# CITY OF PORTLAND, MAINE

Project Name:	Mixed Use Building	Project ID:	2017-285
Address:	147-155 Washington Avenue	CBL:	012 G001001
Applicant:	Diving Rock LLC		
Planner:	Shukria Wiar

**Subject:** B-1 Design Review – 155 Washington Avenue  
**Written by:** Caitlin Cameron, Urban Designer  
**Date of Review:** Tuesday, March 6 2018

# PLANNING BOARD REPORT PORTLAND, MAINE

Figure 2: Proposed Site Plan

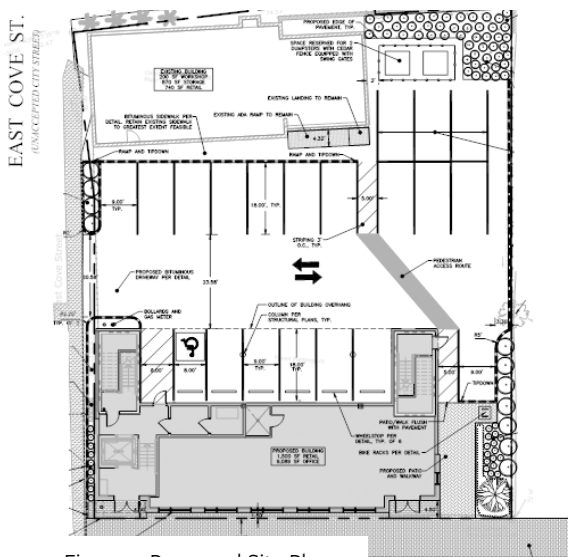
serve as the sole vehicle ingress and egress. East Cove Street is a vacated street by omission (accidentally not listed in the Council Order for unaccepted streets in 1997). The paved width of this street is approximately 28 feet, which includes an approximately 4-5 feet sidewalk. According to Tom Errico's review, access will be tight, but acceptable for vehicles. However, the Fire Department is looking at the access for public safety vehicles and is seeking a clear travel lane of 20 feet. The applicant's consultants are working with the city staff to develop a site plan that meets this standard. A more detail site plan will be available at the Board's public hearing.

Street trees are to be provided every 30 to 45 feet along the street frontage. This ratio equates to a minimum of two trees. Given the limited area, one street tree is proposed just into the private property. A street tree is not proposed within the public right-of-way because there is a sewer main that runs beneath the sidewalk. Jeff Tarling, City Arborist, has reviewed the landscaping plan and recommended on March 22, 2018, the following:

Prior to the public hearing, staff will clarify Jeff Tarling's recommendations regarding street trees, as it is unclear if he is aware that the sewer line is in the sidewalk. The applicant has the option to contribute to the City's Street Tree Fund in place of the one tree that will not be planted.

Staff has recommending and specifying the city's Bayside Medium (black) fixtures on Washington Avenue frontage. The landscaping plan will need to be revised to depicted one Bayside Medium LED street light fixtures on the frontage as requested by staff.

6. The applicant shall revise the site plan to include relocating the proposed building to the south by up to three feet to meet the required driveway standard of 20' for fire access. The applicant shall also provide a turning template to confirm adequate vehicle access assuming a vehicle is parked on the east side of East Cove Street.

7. The applicant shall revise the site plan to show the use of paint or contrasting materials to delineate the pedestrian access route.
8. The Applicant shall work with staff to add landscaping on the southeast corner of the site adjacent the tandem spaces.
